Work Order ID 78059

Item Name: Replacement Skidtube

DRAWING NO. D2580	TITLE 205 SKIDTUBE ASSEMBLY	REV. E	DART AEROSPACE LTD ENGINEERING ORDER		D.E.O. NO. D2580-E-1	SHEET NO. SHEET 1 OF 1	SCALE NTS
DRAWN <i>UP</i>	CHECKED <i>ASS</i>	MFG. APPR. <i>ER</i>	APPROVED <i>[Signature]</i>		DE APPR. <i>[Signature]</i>		
DATE 11.12.13	DATE 11.12.13	DATE 11.12.13	DATE 11.12.13		DATE 11.12.13

CHANGE ALL C'BORED WELDED CROSSBOLT SPACERS TO SWAGED SPACERS

D2580-041 ASSEMBLY DETAIL

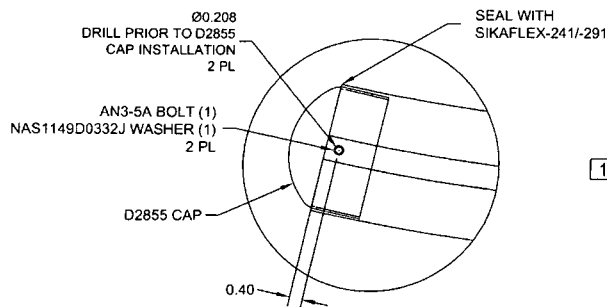
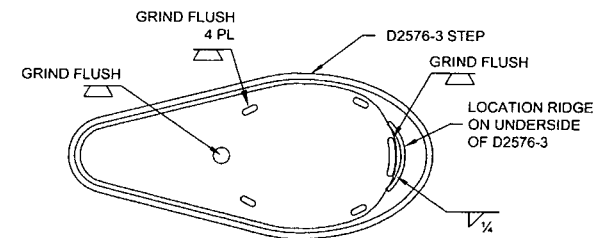
- AFTER DRILLING AND BENDING ASSEMBLY
PERFORM THE FOLLOWING FOR Ø0.508 HOLES ONLY:
1. CHAMFER HOLE 0.050 X 45°
 2. INSERT D2579 SPACER (20 PLACES)
 3. WELD INTO PLACE AND GRIND FLUSH
 4. C'BORE D2579 SPACER TO Ø0.437 X 1.00 DEEP

- ~~1. CHAMFER HOLE 0.060 X 45°~~
- ~~2. INSERT D2579 SPACER (20 PLACES)~~
- ~~3. WELD INTO PLACE AND GRIND FLUSH~~
- ~~4. C'BORE D2579 SPACER TO Ø0.437 X 1.00 DEEP~~
1. INSERT D4202-1 SPACER, 20 PL (-041) OR 20 PL (-045) OR 25 PL (-047)
2. SWAGE TO Ø0.437 X 1.00 DEEP PER QSI 002
3. TRIM / GRIND FLUSH PER QSI 002

SECTION B-B, F-F, I-I
NOT TO SCALE

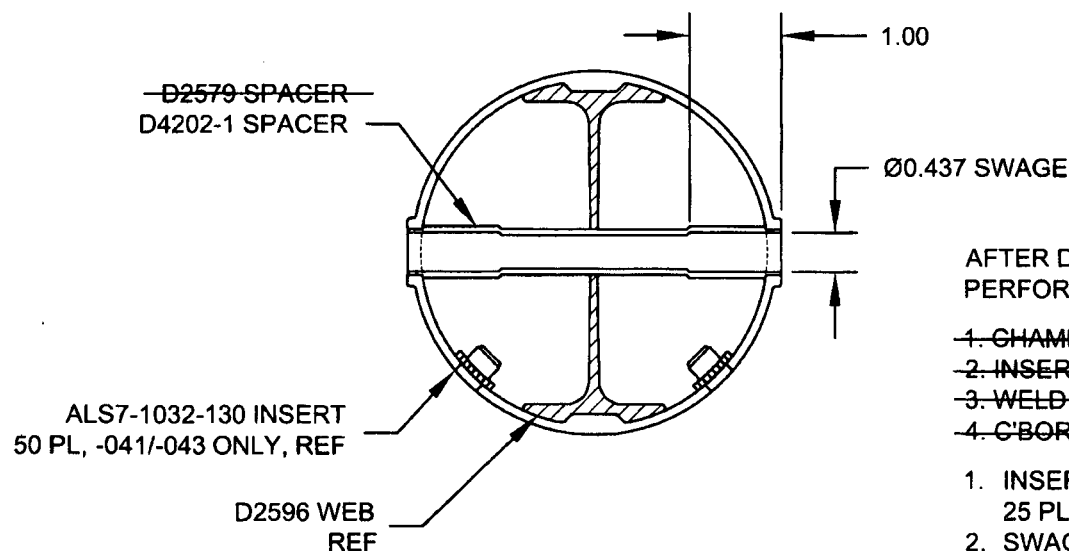
SECTION B-B, SECTION F-F, & SECTION I-I ARE AMENDED AS FOLLOWS
FOR ALL HOLES THAT WERE ORIGINALLY C'BORED:

WELD 4X D2579 SPACERS PER DWG
IN LOCATIONS MARKED "NO C'BORE".
REF SHEET 4 OF DWG.
